RHODE ISLAND DEPARTMENT OF TRANSPORTATION

RHODE ISLAND CONTRACT NO.2019-CB-027

Bridge Group 51A - Rt 37 C-2

ADDENDUM NO. 4 Prospective bidders and all concerned are hereby notified of the following changes in the Plans, Specifications, Proposal and Distribution of Quantities for this contract. These changes shall be incorporated in the Plans, Specifications, Proposal and Distribution of Quantities, and shall become an integral part of the Contract Documents.

BRIDGE 062901 PROFILE
 SCALE: 1" = 40' HORIZ.
 SCALE: 1" = 8' VERT.

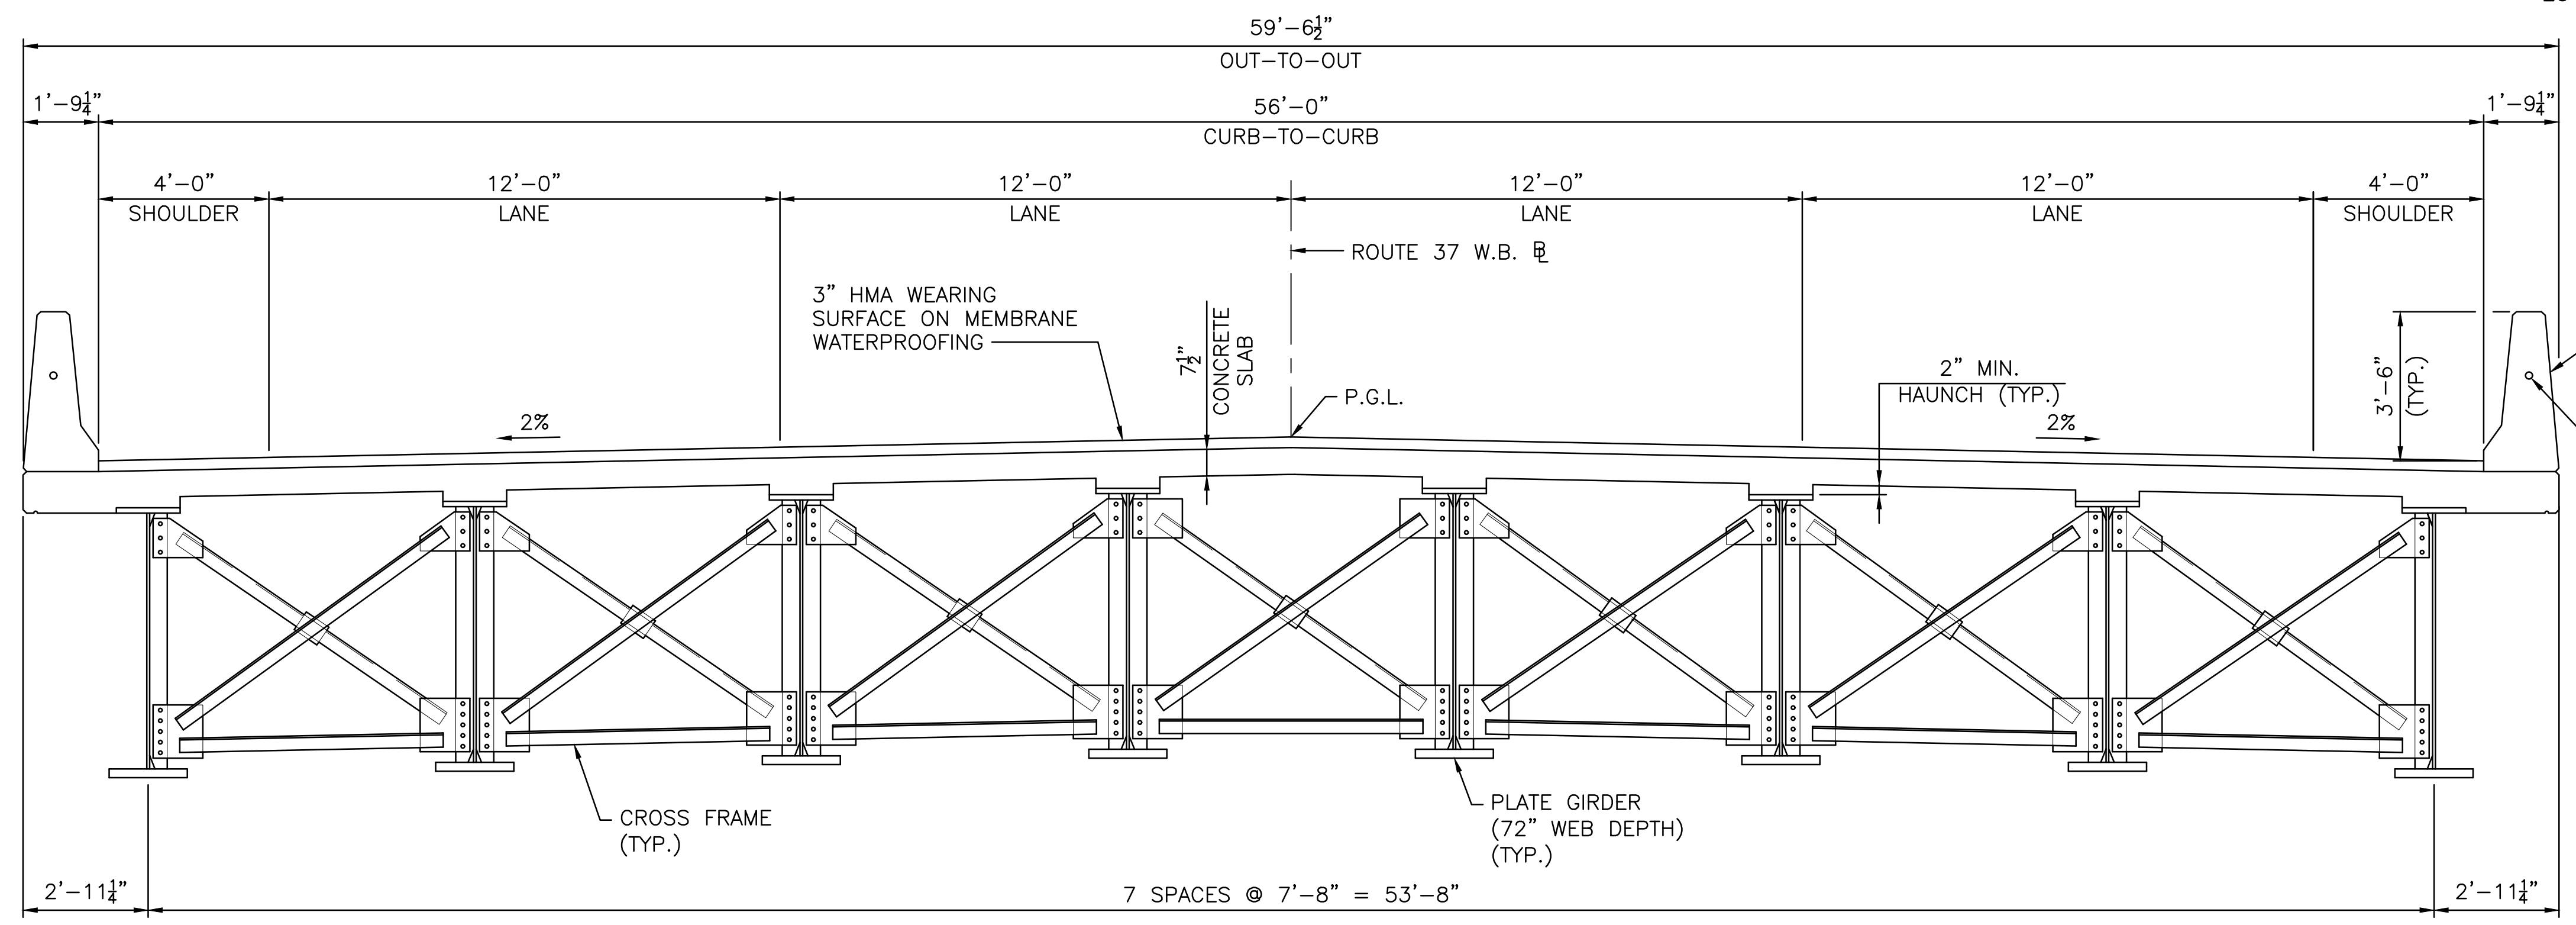
Delete plan sheets 6, 7, 24, 35, 37, 41, 48, 49, 64, 74, 75 in their entirety and replace them with Sheets 6 (R-1), 7 (R-1), 24 (R-1), 35 (R-1), 37 (R-1), 41 (R-1), 48 (R-1), 49 (R-1), 64 (R-1), 74 (R-1), 75 (R-1) attached to this Addendum No. 4. Various notes and callouts have been added or revised to clarify pay items and address other questions raised by bidders. In addition, the HMA wearing surface on the bridge deck and approach slabs has been revised.
